**Master Plan Amendment #2020-00003**  
**CDD Concept Plan #2020-00003**  
**Zoning Text Amendment #2020-00006**  
**2412, 2514 & 2610 Richmond Highway; 2500 Oakville Street; 400 Fannon Street; 300, 403, 405 & 420 Swann Avenue; 400 Calvert Avenue**

Approval of amendments to the Potomac West Small Area Plan chapter of the Master Plan through the Oakville Triangle & Route 1 Corridor Vision Plan and Urban Design Standards & Guidelines overlay, amendments to CDD#24 Concept Plan, and initiation of and text amendment to the Zoning Ordinance for a mixed-use development of the Oakville Triangle with Conditions.

**MPA2020-00003, CDD2020-00003, ZTA2020-00006**  
**Oakville Triangle Vision Plan & CDD Concept Design Plan Amendments**

Figure 7: Oakville Triangle District

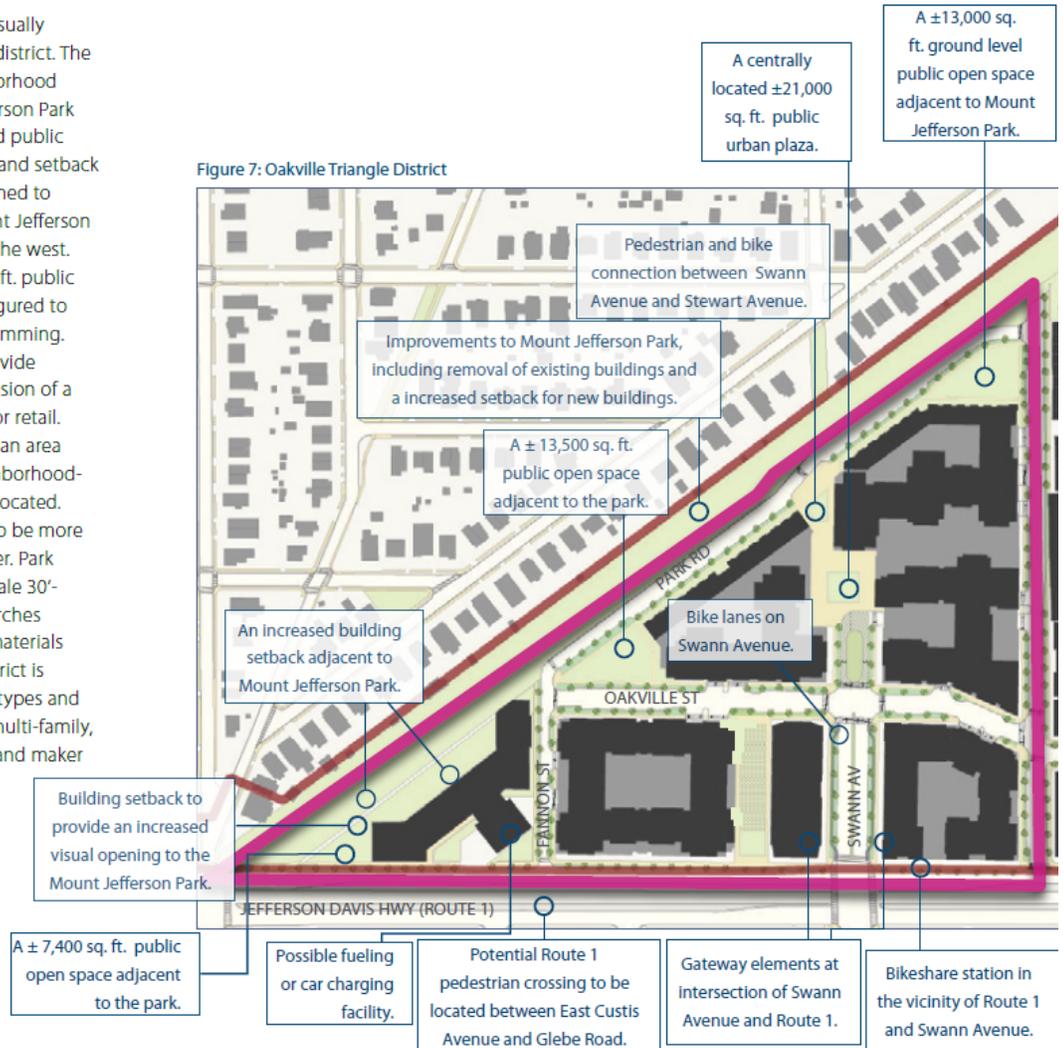
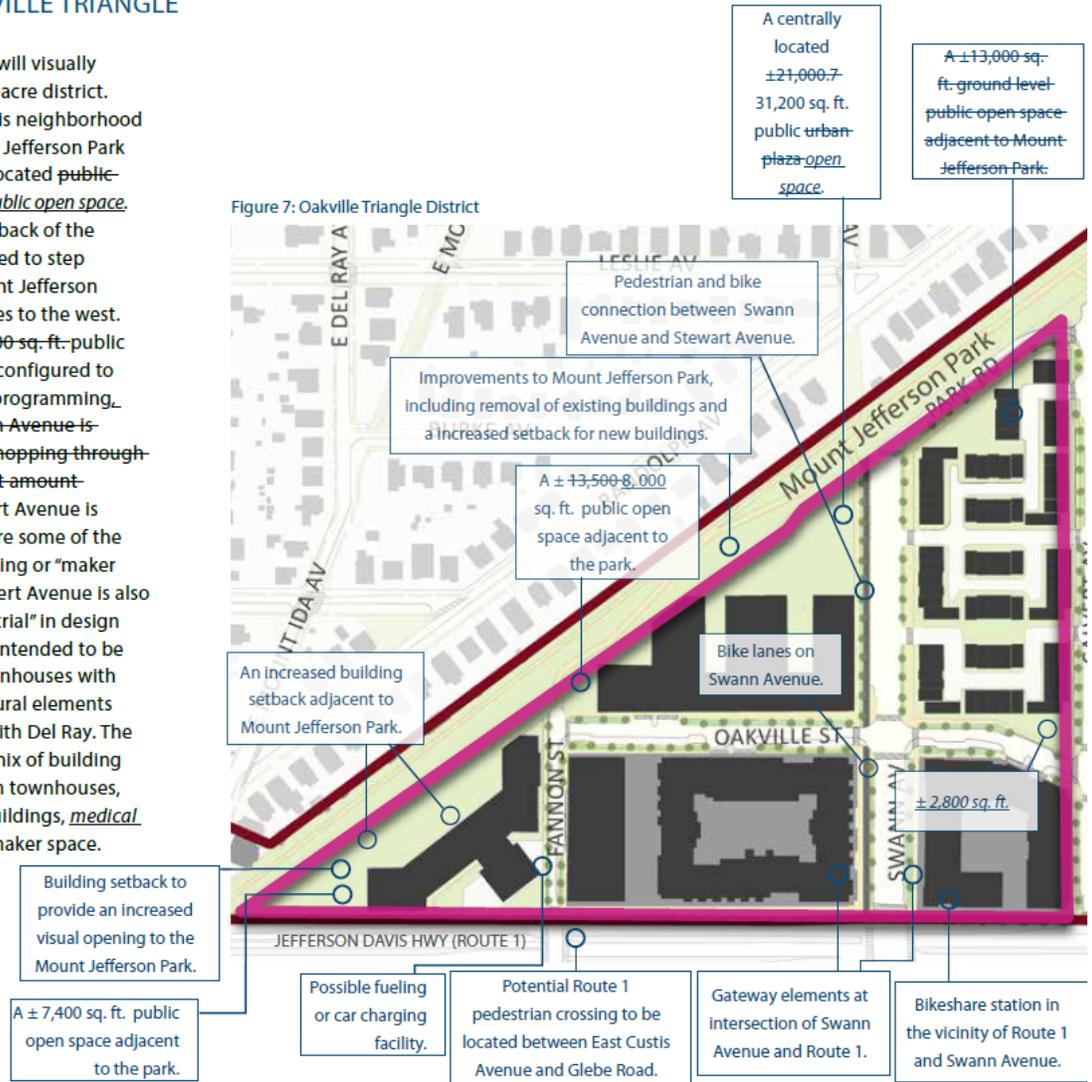
Establishing the street grid will visually unify this approximately 15-acre district. The defining elements of this neighborhood will be the adjoining Mount Jefferson Park frontage and the centrally located public urban plaza  $\pm 31,200$  sq. ft. public open space. The building height and setback of the buildings have been designed to step down to the adjoining Mount Jefferson Park and single-family homes to the west. The centrally located  $\pm 21,000$  sq. ft. public open space will need to be configured to accommodate events, and programming, and social gatherings. Swann Avenue is intended to provide retail shopping through the provision of a significant amount of ground floor retail. Calvert Avenue is intended to be an area where some of the existing neighborhood-serving or "maker uses" could be located. Calvert Avenue is also intended to be more "industrial" in design and character. Park Road is intended to be smaller scale 30'-45' tall townhouses with front porches and architectural elements and materials compatible with Del Ray. The district is intended to be a mix of building types and uses ranging from townhouses, multi-family, office, hotel buildings, medical care facility, and retail and maker space.

**FANNON STREET (WITH REDEVELOPMENT)**

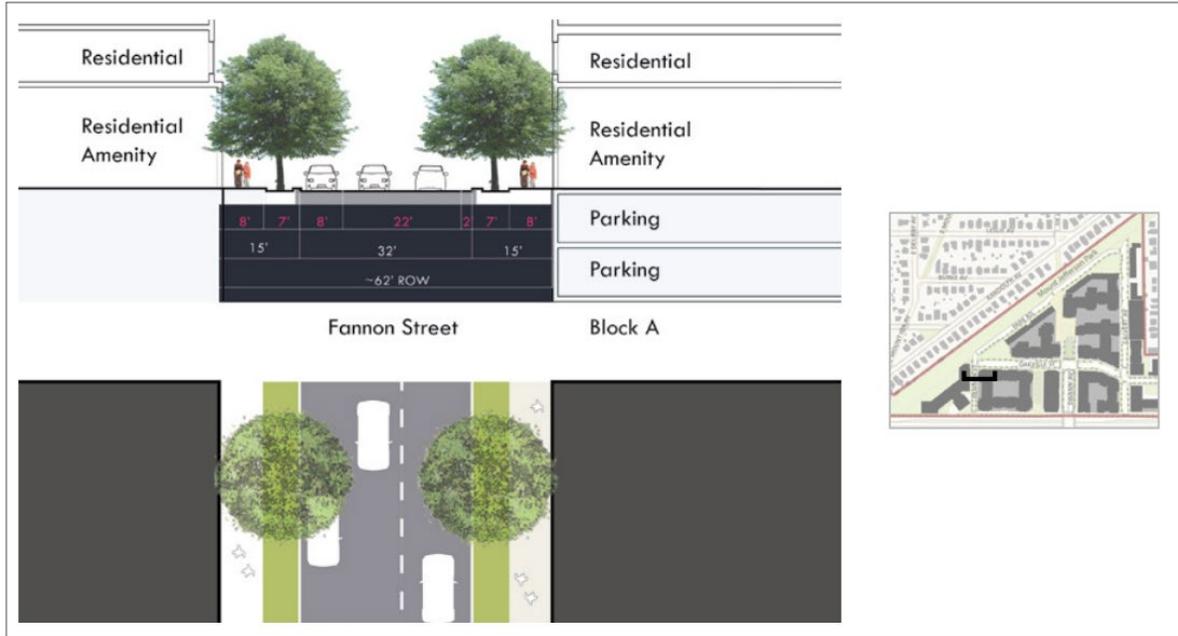
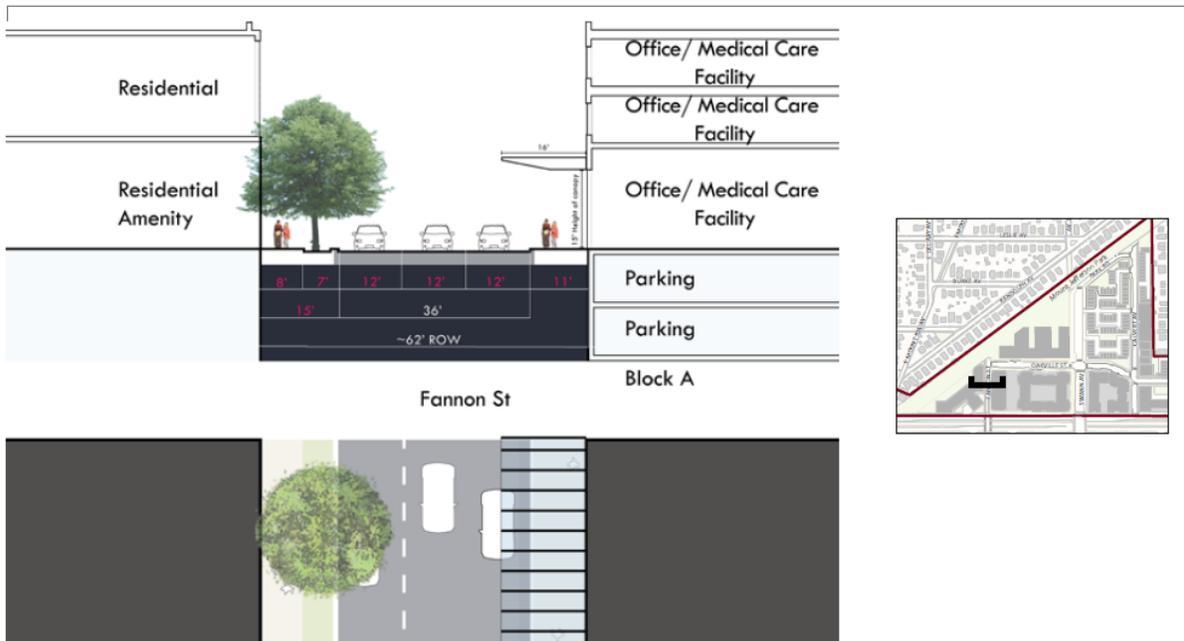
p.118 (Proposed)

**C. PARK ROAD**

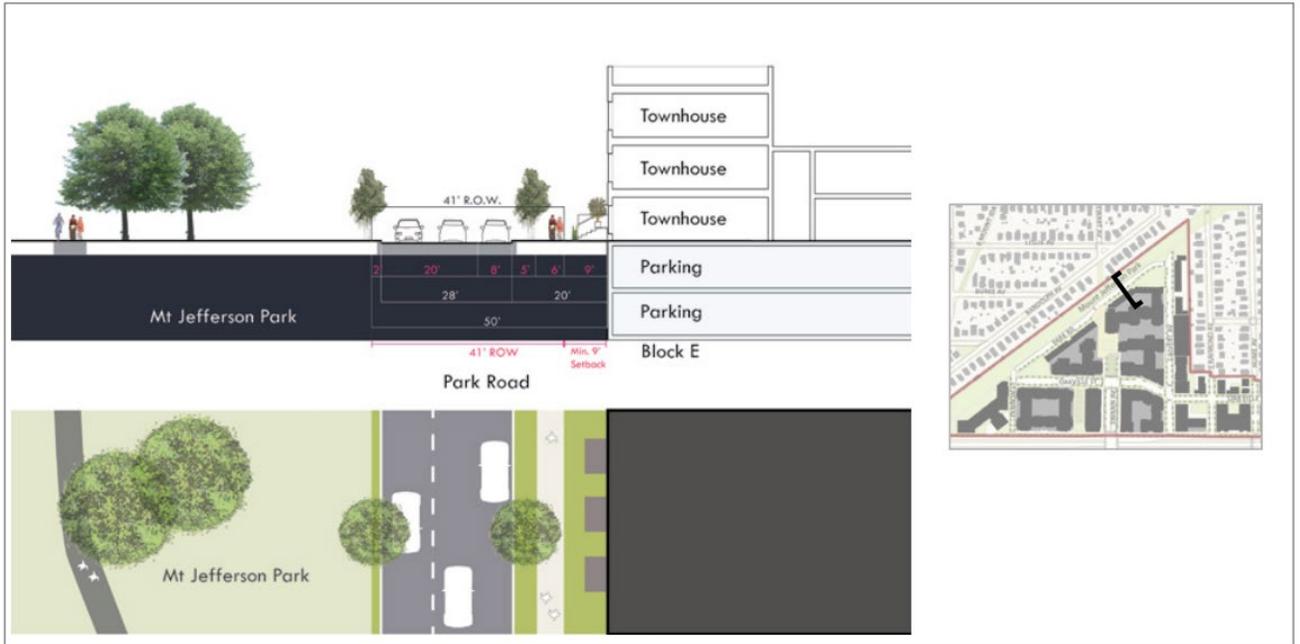
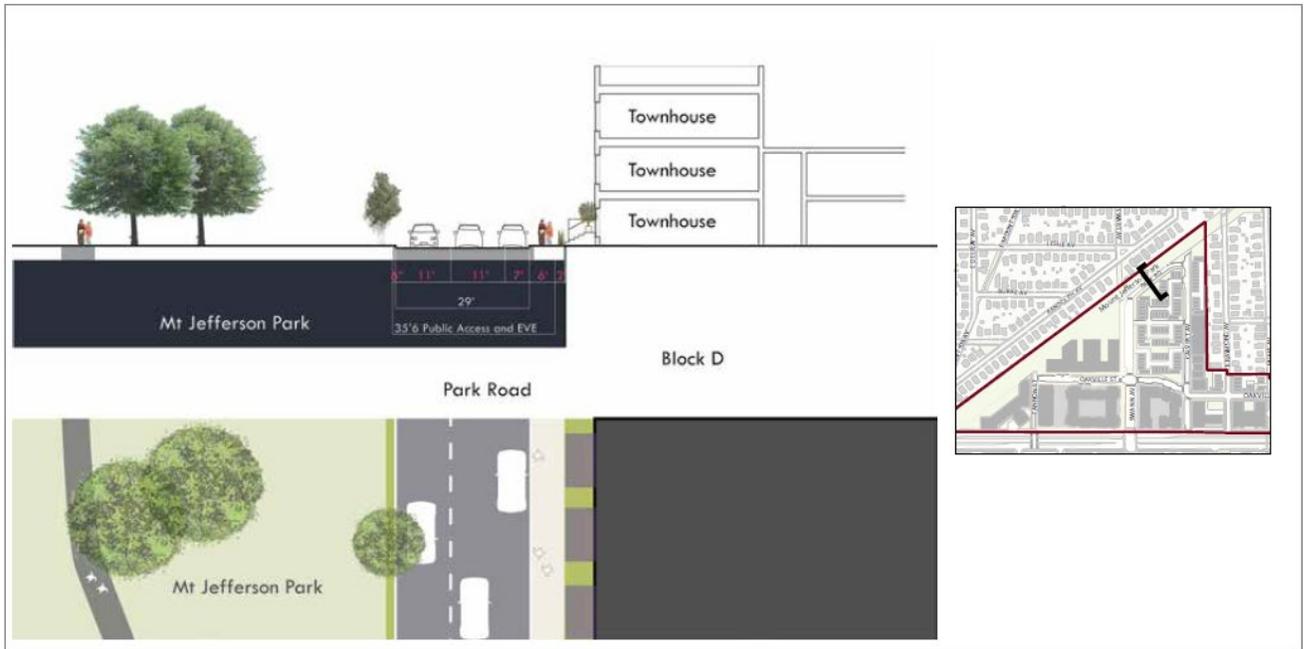
p.119 (Proposed)

Figure 30: Proposed Open Spaces adjacent to Mount Jefferson Park

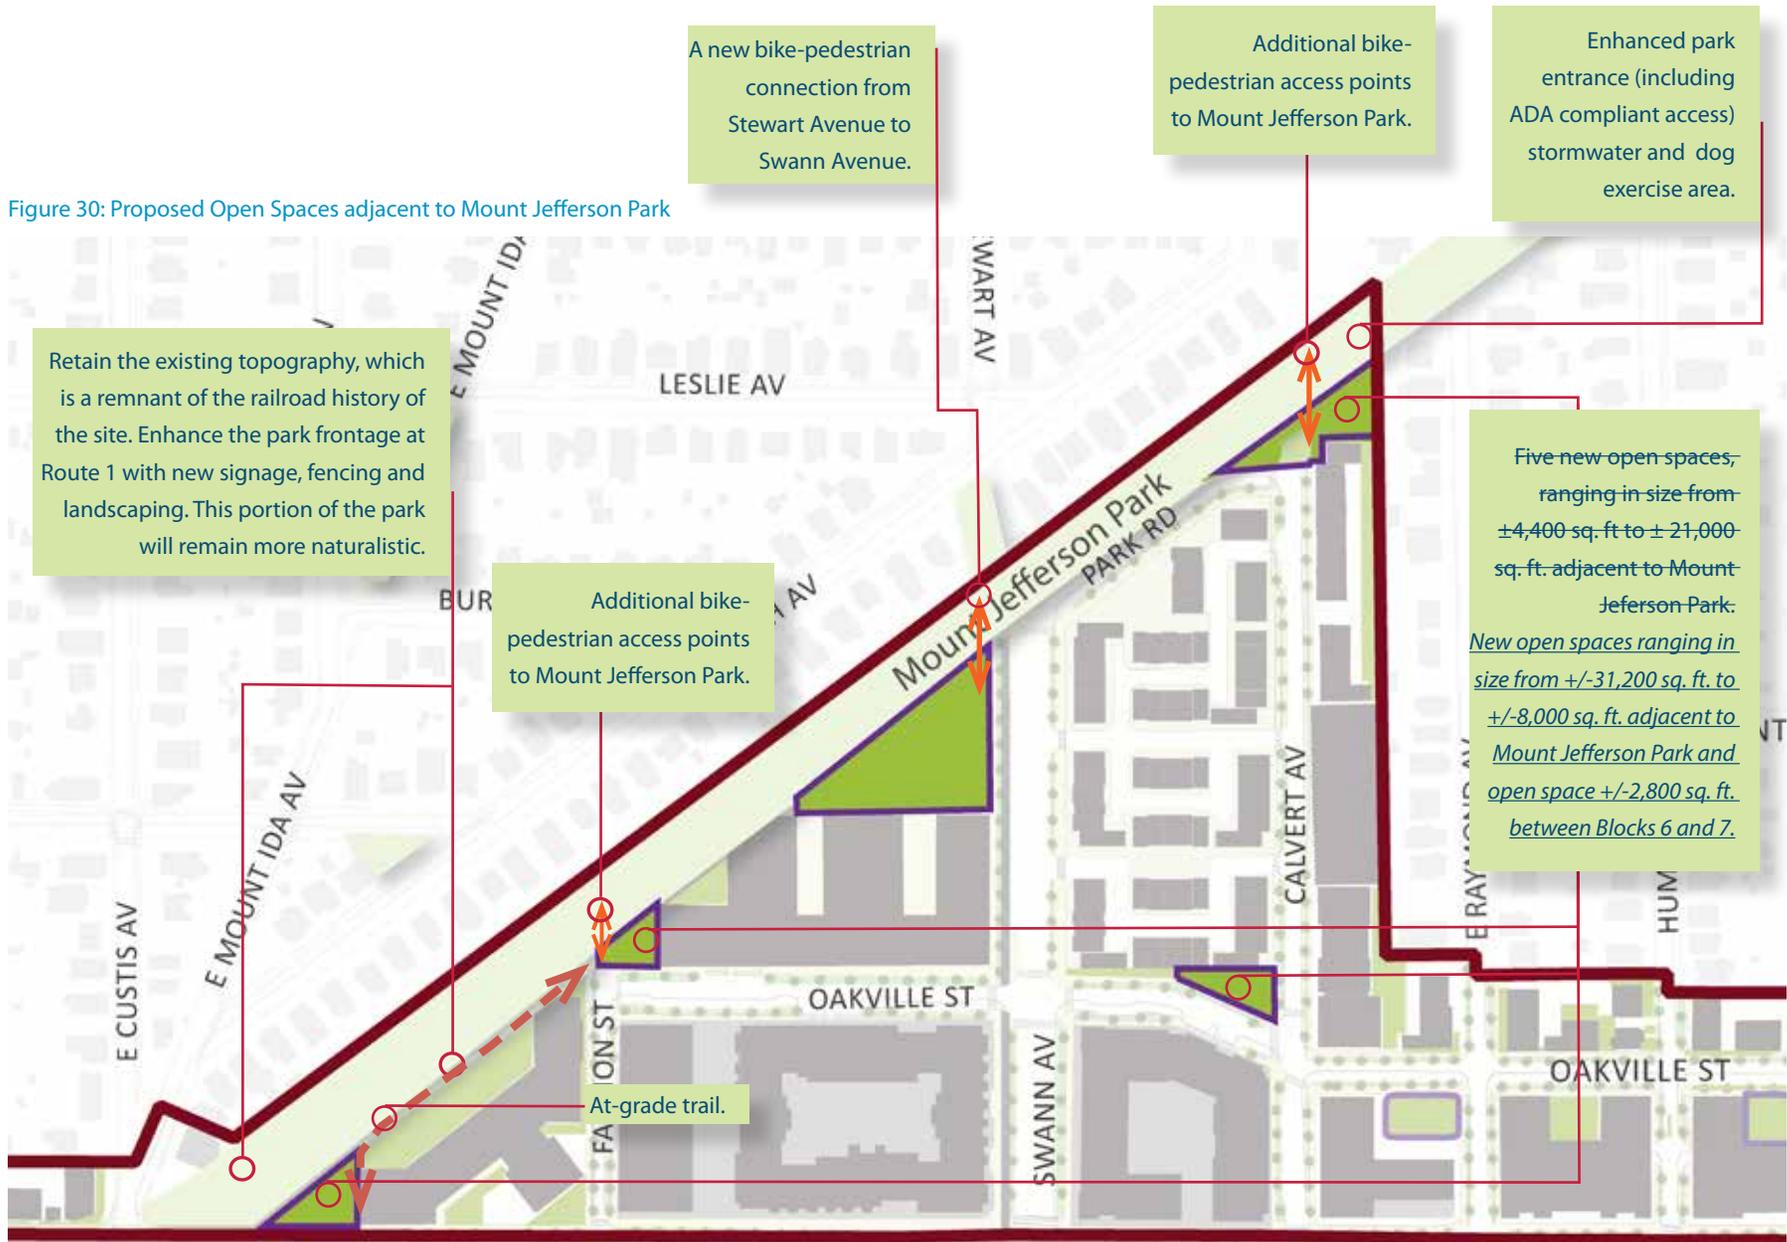
4.18 The ~~five~~ *four* new open spaces adjacent to Mount Jefferson Park shall be constructed as generally depicted in Figure 30, as part of the redevelopment adjacent to the Mount Jefferson Park. The at-grade trail (lower trail) extension on the northern portion constructed by the adjoining property owner.
